PCN Number:	20160908002	**PCN Date:**	Sept 19, 2016
Title:	Assembly and Test site move from MLA to PTIAT for Select Devices		
Customer Contact:	PCN Manager	**Dept:**	Quality Services
Proposed 1st Ship Date:	Dec 19, 2016	**Estimated Sample Availability:**	Date provided at sample request

Texas Instruments Incorporated is announcing the Assembly and Test site move from MLA to PTIAT for Select Devices listed in the "Product Affected" Section. No Material differences between Sites.

Sample product shipping label to show code location (not actual product label)

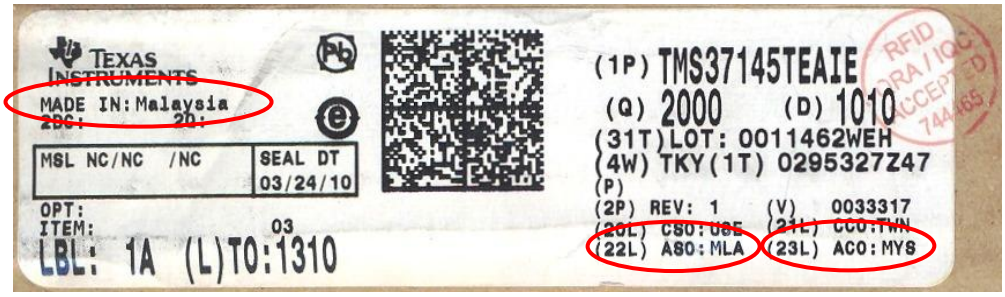
Changes to product identification resulting from this PCN:

TI Malaysia	Assembly Site Origin (22L)	ASO: MLA
Powertech Technology Inc.	Assembly Site Origin (22L)	ASO: PT2

ASSEMBLY SITE CODES: MLA=K, PT2 =C
